# SPARE PARTS BULLETIN

Subject: **Capacitor Change**

Part No. 012-001-087 to 012-001-089,  
012-001-114 to 012-001-129

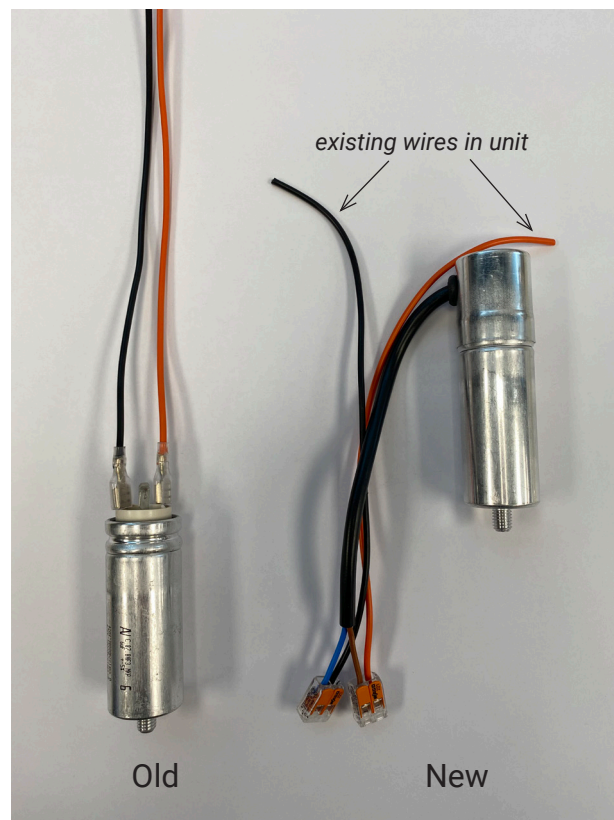
Higher temperature specification

- New capacitors come with soldered terminals, metal cap and a 200mm fly lead
- The mounting stud is the same as item it replaces, ie M8 stud
- Terminal connectors 2 way push-in (001-002-144) are available to join old and new wires.

012-001-115 to supercede 012-000-138	(3 Mfd)
012-001-116 to supercede 012-000-146	(3.5 Mfd)
012-001-117 to supercede 012-000-120	(4 Mfd)
012-001-087 to supersede 012-000-124	(5 Mfd)
012-001-088 to supersede 012-000-121	(6 Mfd)
012-001-089 to supersede 012-000-127	(8 Mfd)
012-001-114 to supersede 012-000-122	(10 Mfd)
012-001-118 to supersede 012-000-137	(12 Mfd)
012-001-119 to supersede 012-000-123	(15 Mfd)
012-001-120 to supersede 012-000-125	(18 Mfd)
012-001-121 to supersede 012-000-151	(22.5 Mfd)
012-001-122 to supersede 012-000-129	(30 Mfd)
012-001-123 to supersede 012-000-148	(35 Mfd)
012-001-124 to supersede 012-000-147	(40 Mfd)
012-001-125 to supersede 012-000-149	(45 Mfd)
012-001-126 to supersede 012-000-133	(50 Mfd)
012-001-127 to supersede 012-000-134	(55 Mfd)
012-001-128 to supersede 012-000-150	(60 Mfd)
012-001-129 to supersede 012-000-152	(80 Mfd)
